Docket Item # 2
BAR CASE # 2010-0195

BAR Meeting
July 28, 2010

ISSUE: Alterations
APPLICANT: Scott & Jennifer Wagner
LOCATION: 1226 Oronoco Street
ZONE: RB Zone/ Residential

Figure 1. Proposed Fence Locations

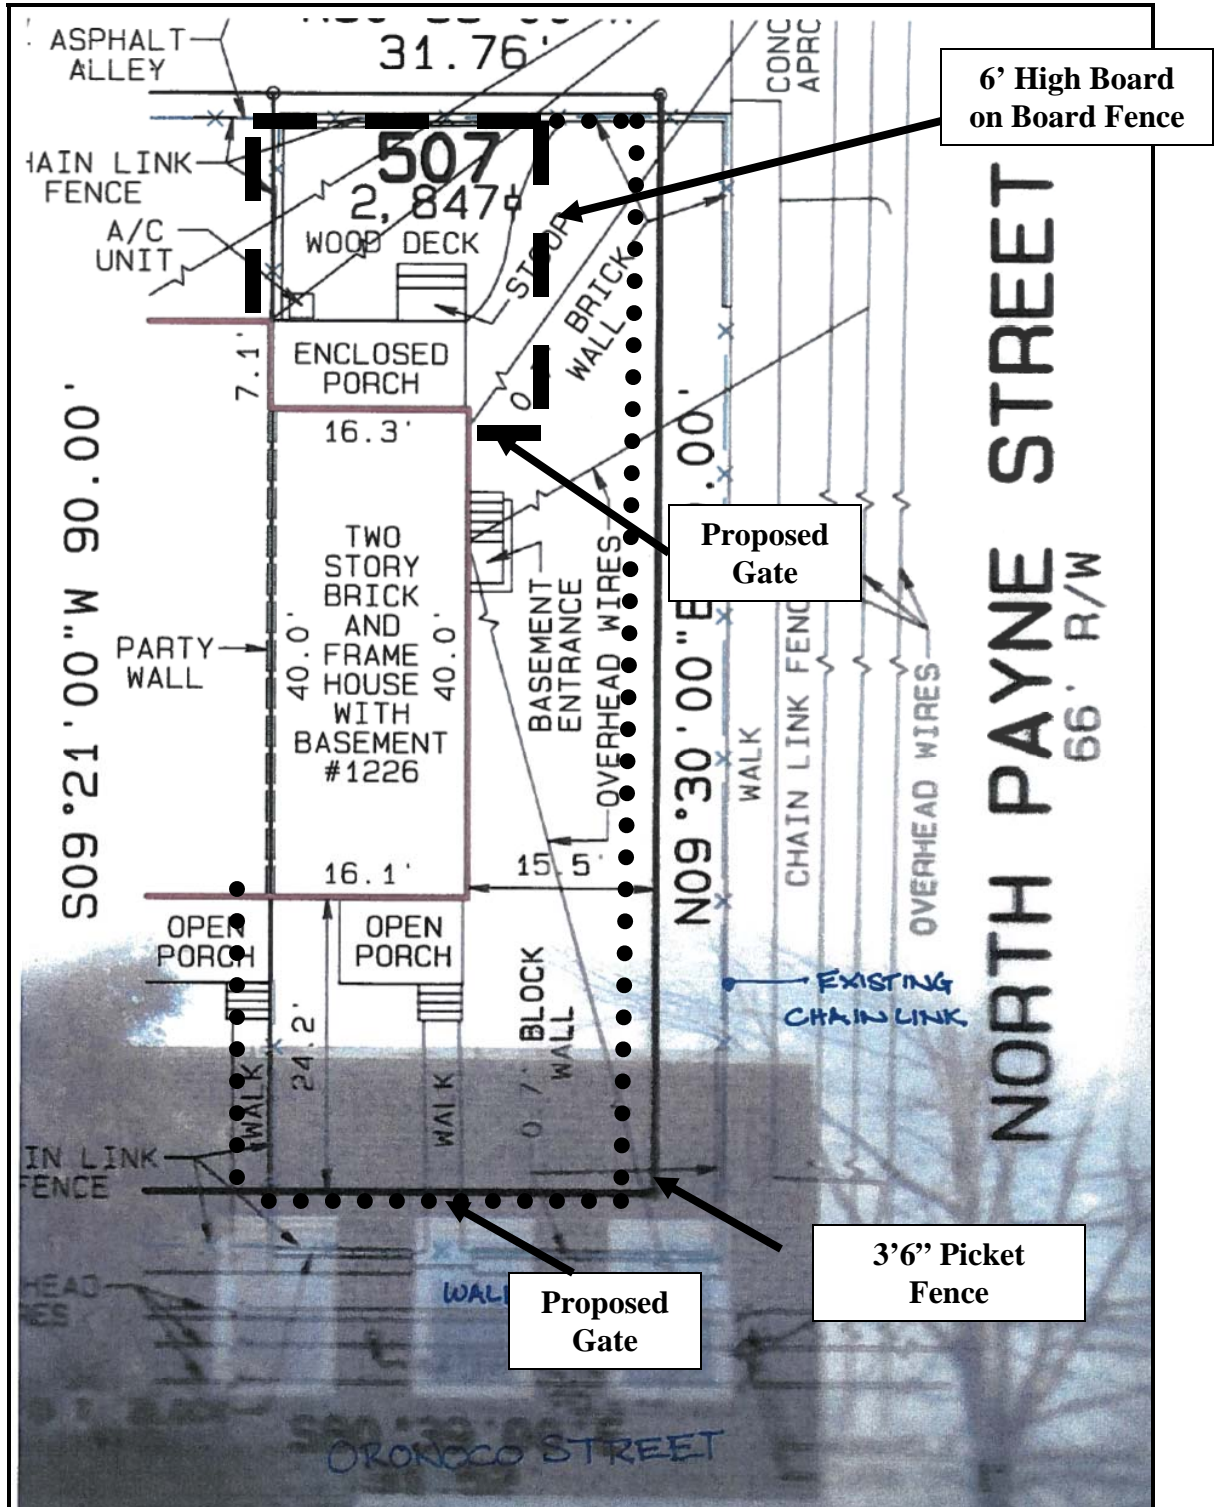
1. That the proposed 3.5' and 6.0' replacement fences must be erected only on the subject property per locations shown on submitted survey.
2. That the wood fences are painted or stained.

The chain link fence along the side and front of the subject house is currently located within the City right-of-way. The new wood, board-on-board, and the dog-eared, spaced picket fences will be repositioned on the subject property, as shown on the attached plan (page 4), to comply with zoning regulations. The picket fence must be 50% open per zoning requirements, therefore, there must be a space between the pickets equal to the width of a picket. The proposed design, material specification and location of the proposed fences are consistent with the Guidelines and with other fences approved by the BAR erected in the historic district. Staff recommends approval of the fence construction with the standard conditions above.

Proposed 3.5' and 6.0' replacement fences must be erected only on the subject property per locations shown on submitted survey. Survey indicates that the existing chain link fence is located within the public r-o-w. As proposed the new fences comply with zoning. In addition, the 3.5' fence in a required yard must be 50% open.

Figure 2. Proposed Fence Designs

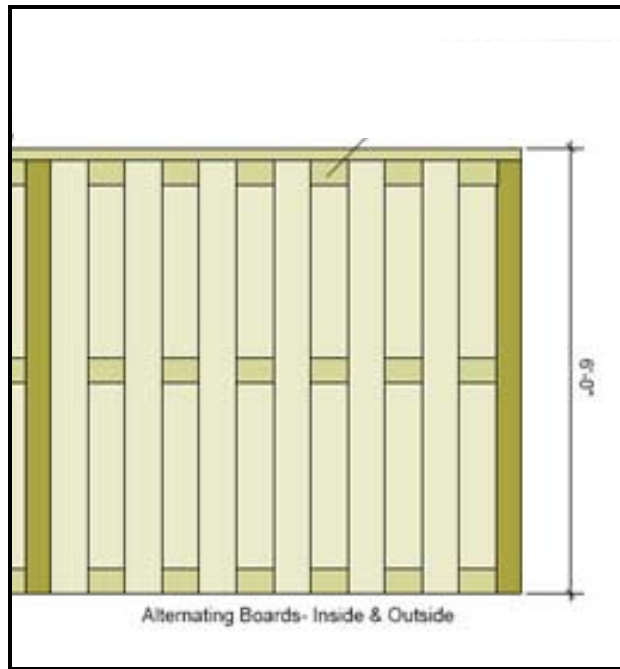
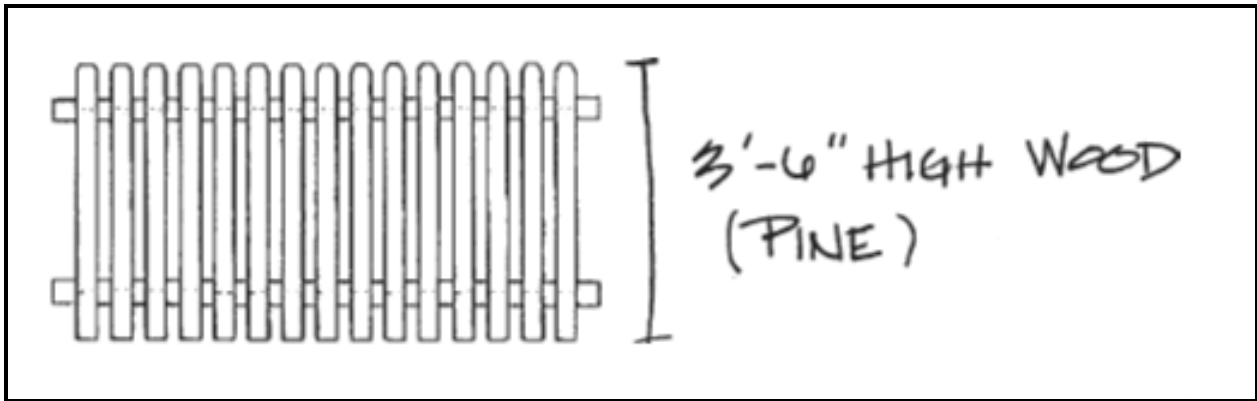
The *Design Guidelines* specify that fencing within the historic district should be appropriate in materials, design and scale to the period and character of the structure they surround and that all fencing must be painted or stained. The *Guidelines* further specify that wood is a traditional material for fences and they generally have vertical pickets.
